GTS Newsletter

2012 / 25E

Machine	TASKI vac 44
Subassembly	Suction Aggregate

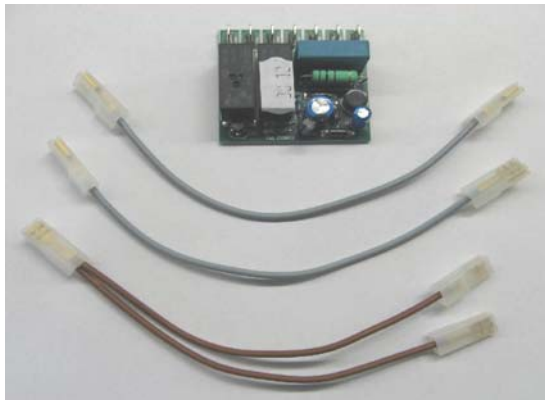
For enhancement as well as for recertification purposes of the TASKI vac 44 our supplier has built in an additional electronic. The main purpose of the electronic is supporting the interference suppression and the reduction of activation peaks transmitted to the local power supply.

On previous models the user had the possibility to activate the required turbine with the relevant switch. This functionality will now be routed by the electronic. In case one of the turbines fails the electronic routes automatically to the other still functioning turbine.

The functionality of the device is not affected by the implementation of the electronic.

Description	Material number	Remarks
Electronic incl wires	4130489 (30018-33)	New spare part number
